Service News

BULLETIN NO. **E-1153** 1/2

RX-V661/RX-V861
HTR-6060/HTR-6080
DSP-AX761/DSP-AX861SE

Diode Replacement

RX-V661/HTR-6060/DSP-AX761 Main P.C.B. (1)

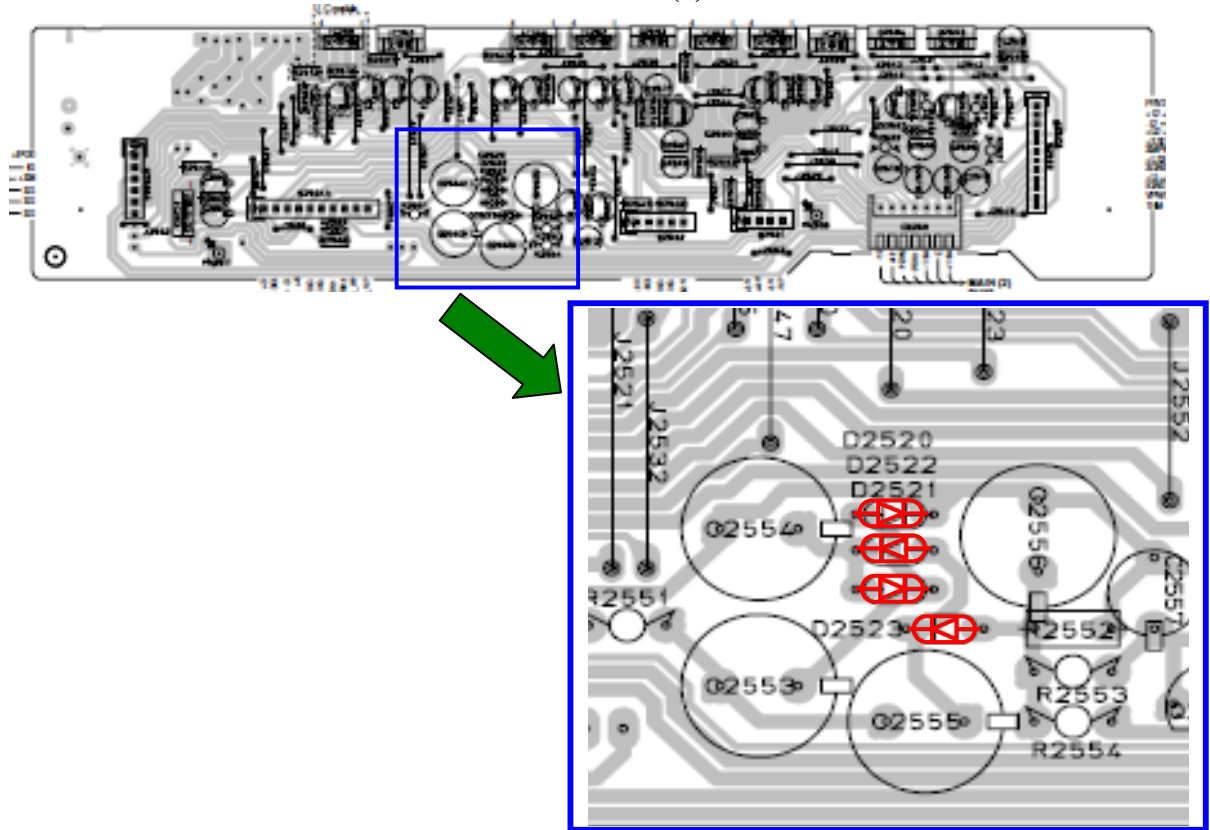
PURPOSE: If “NO POWER” symptom is due to shorted diode and puffed up capacitor in the Main(1)[RX-V661/HTR-6060/DSP-AX761] / Function(2) P.C.B.[RX-V861/HTR-6080/DSP-AX861SE], even if 1 or 2 diodes are shorted, replace all 4 diodes with heavier duty diodes as described below. Capacitors should be replaced with the same/original types.

Previous Parts

Ref. No.	Parts No.	Description
D1001, D1002, D1044, D1045	VN008700	DIODE 1SS270A

New Parts

Ref. No.	Parts No.	Description
D1001, D1002, D1044, D1045	VV307700	DIODE 1N4002S
